801 N. 19TH ST

CIVIC DESIGN REVIEW

Date: 2026.06.09

FIRST FLOOR PLAN

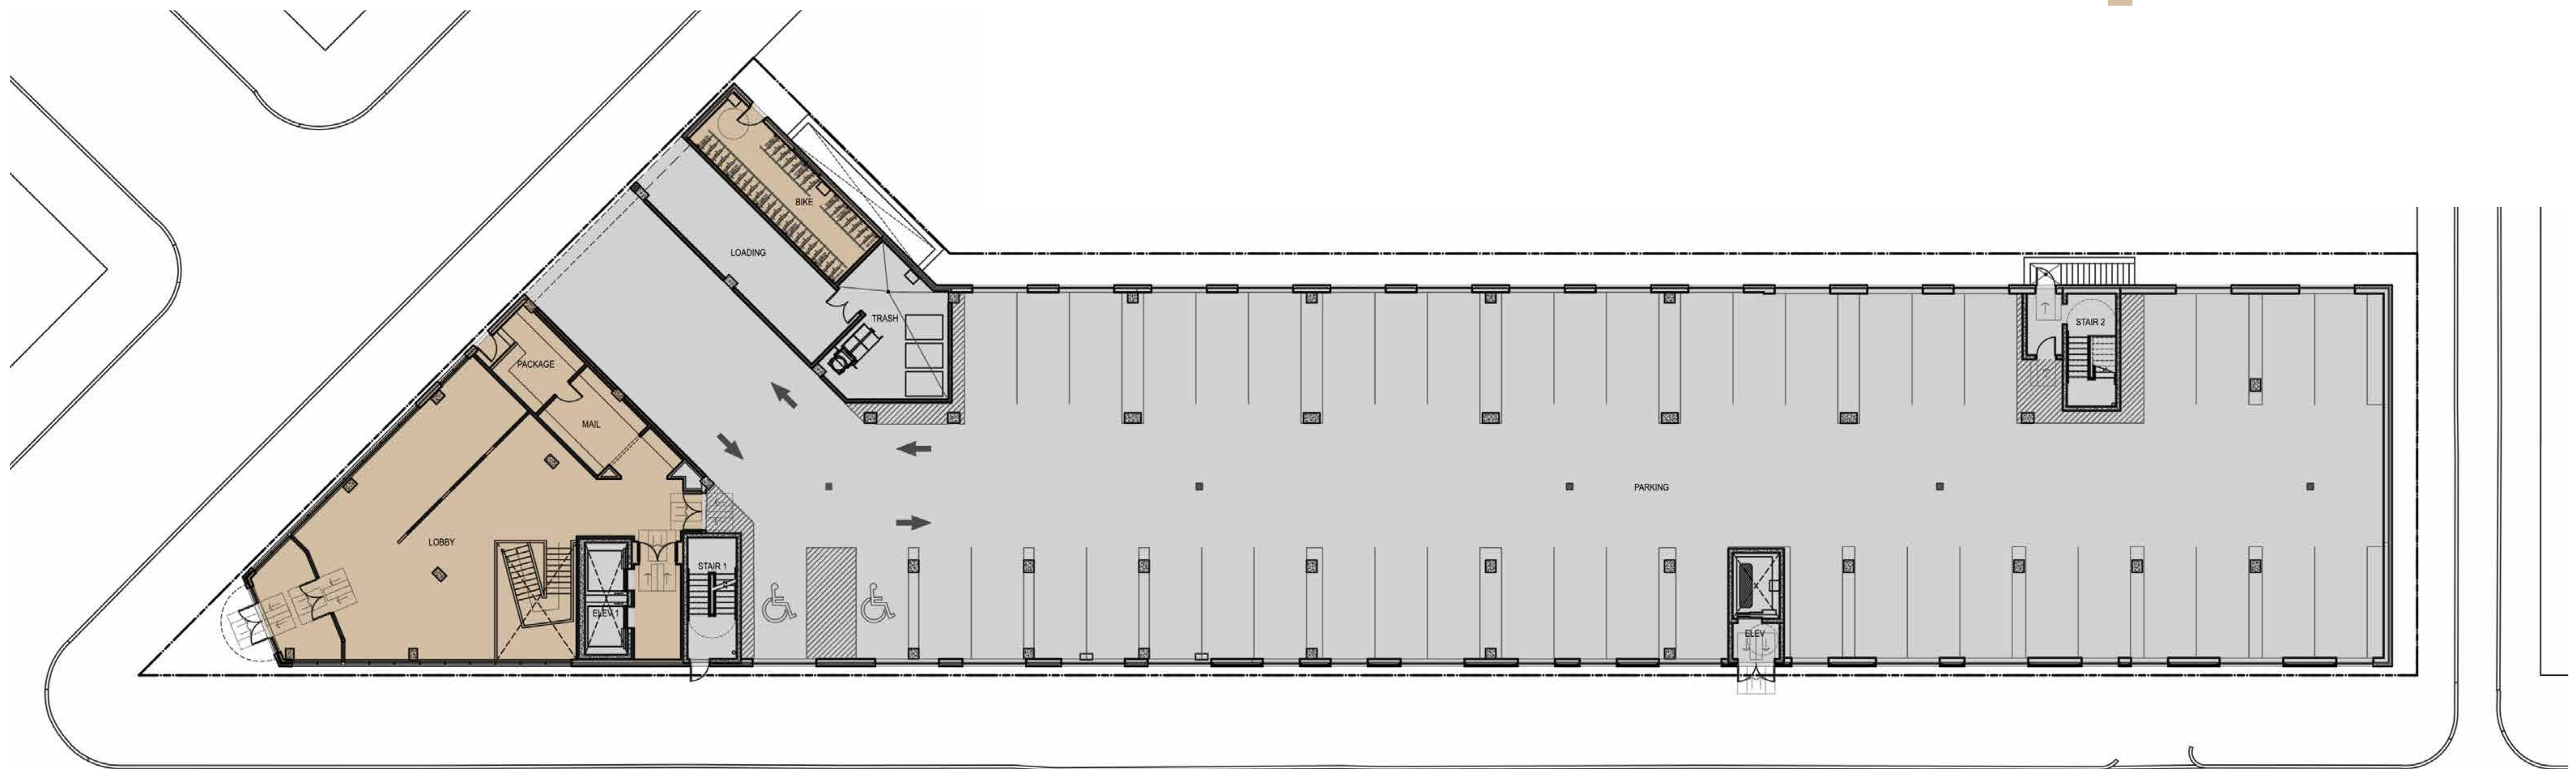
9 Reconsider the circulation of the ground floor to create a connection to the loading zone and bike room to the main lobby area. We will continue to explore the relocation of the bike room into the primary lobby and amenity space of the building. We do not have the ability to relocate the loading zoning, curb cuts, etc. As previously discussed the building is actively under construction, all previous streets department approvals have been obtained, and construction will need to continue accordingly. No change has been made.

ROOF PLAN

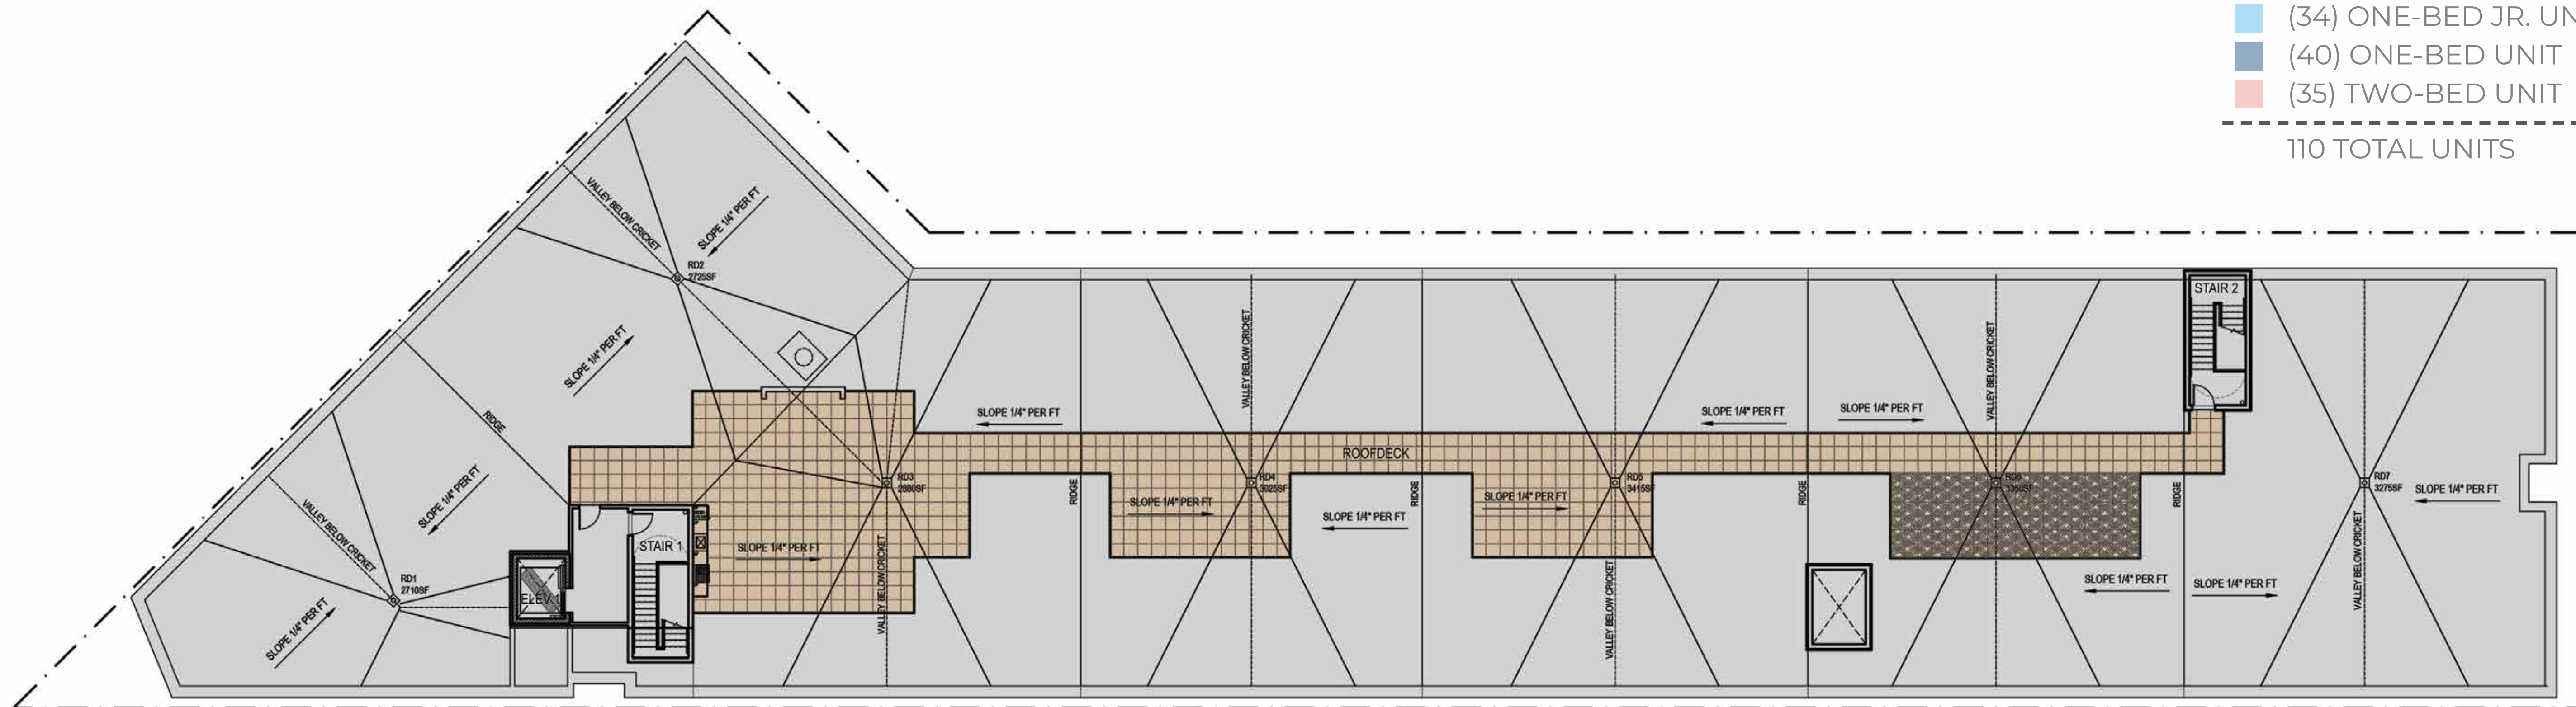
15 Consider on-site renewable energy. Solar panels have been added to the roof, see revised roof plan. These are subtly angled and exist below our parapets to prevent them from being seen from the ROW.

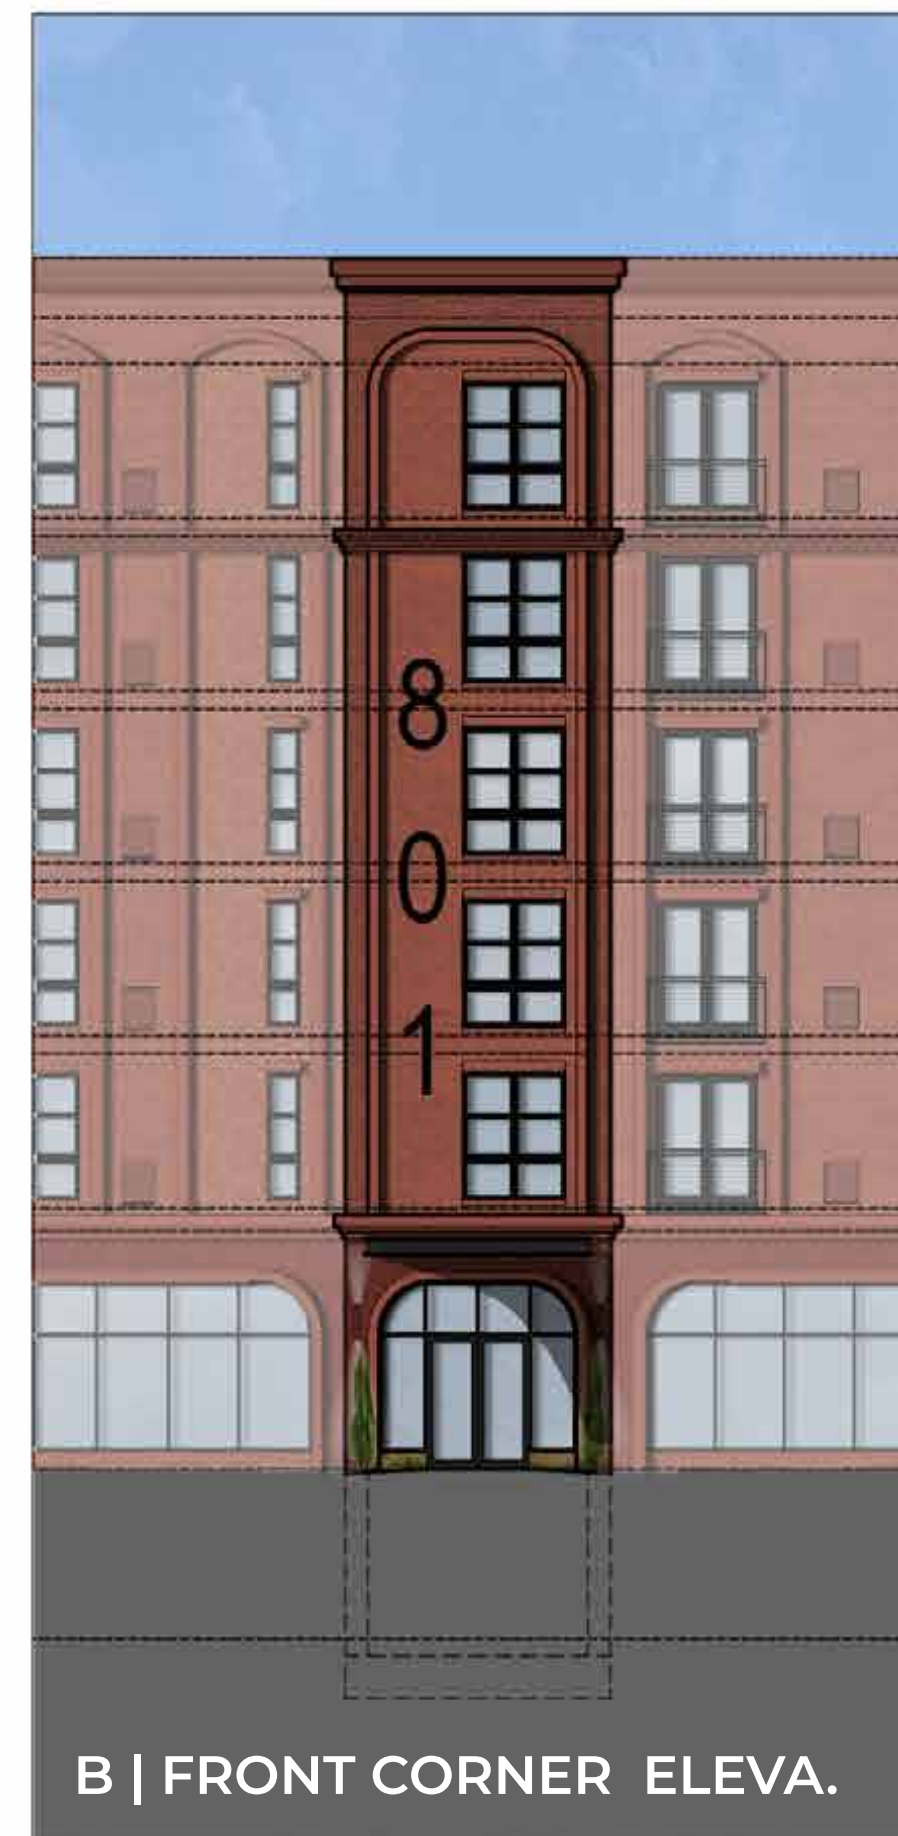
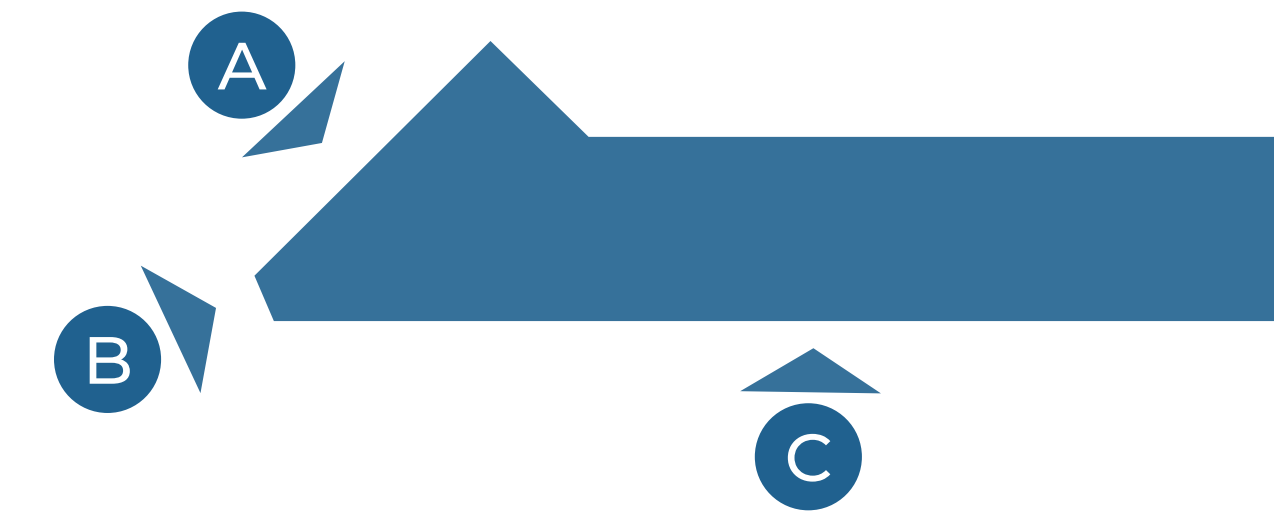
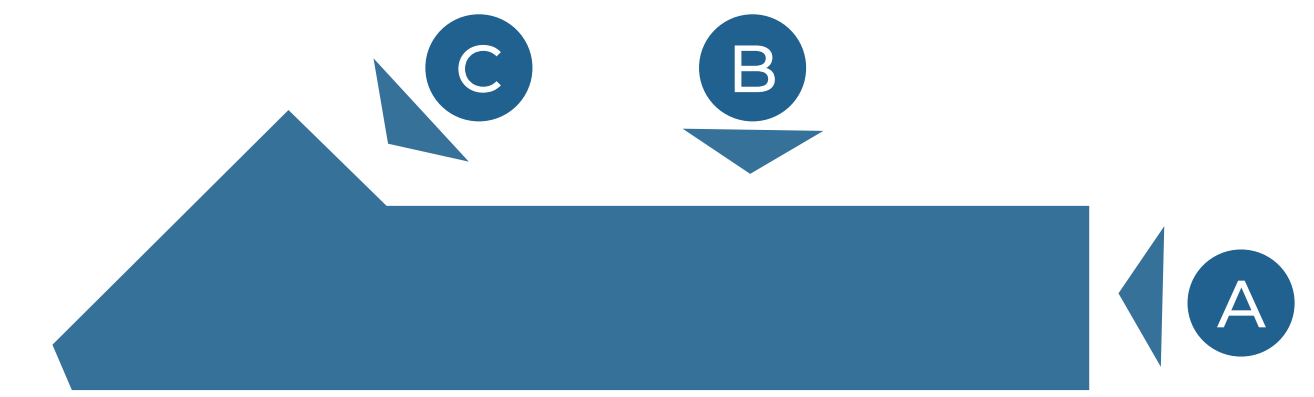
10 The blunt edge of the corner feels awkward, and the asymmetry does not work. Consider ways to make that corner a statement piece. The building's design embraces asymmetry, and relies on rhythm and balance to achieve overall design cohesion. At the Commission's request, we revised this corner to provide additional prominence while maintaining asymmetry. See revised elevations and renderings.

11 Would like to see a double floor lobby to open up to the corner more. The current lobby height is 13' and is more than adequate for this building. We have revised the corner and lobby entrance. See response 10 above.
